MONTGOMERY COUNTY HISTORIC PRESERVATION COMMISSION
STAFF REPORT

Address:	4711 Waverly Avenue, Garrett Park	Meeting Date:	1/11/2023
Resource:	Outstanding Resource (Garrett Park Historic District)	Report Date:	1/04/2023
Applicant:	Michelle & Malcolm Russell-Einhorne Kwasi Hemeng, Architect	Public Notice:	12/28/2022
Review:	HAWP	Tax Credit:	n/a
Permit Number:	1015715	Staff:	Dan Bruechert
Proposal:	Building Addition

Russell Residence
 Proposed Remodel Project
 4711 waverly Avenue, Garrett Park, MD 20896
 Cover Sheet

Window Schedule

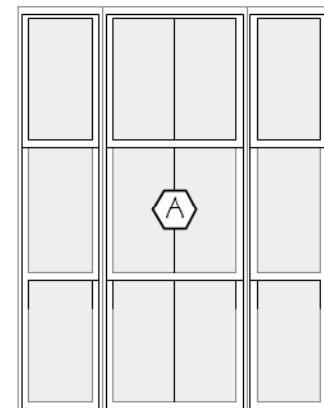
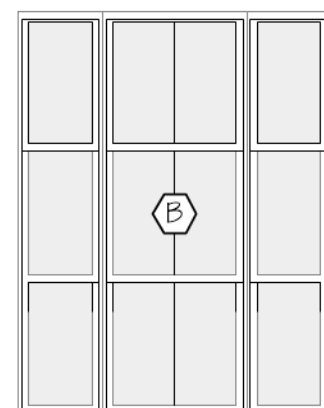
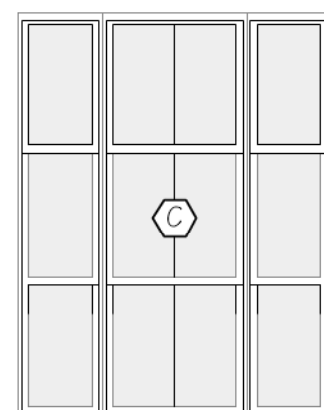
1. The new windows need to be what Andersen calls “full divided lights,” which includes permanently affixed interior and interior grilles with spacer bars. Drawings reflecting this condition has been satisfied will be submitted to Staff prior to the release of the HAWP approval documents.

grilles with a spacer bar between the panes; Andersen calls this “Full Divided Light” in their product guide. Staff finds, except for the missing grille detail, the windows are appropriate and recommends the HPC add a condition for approval that the windows need to be “Full Divided Light” and documentation needs to be submitted to Staff satisfying this condition before Staff releases permit documents.
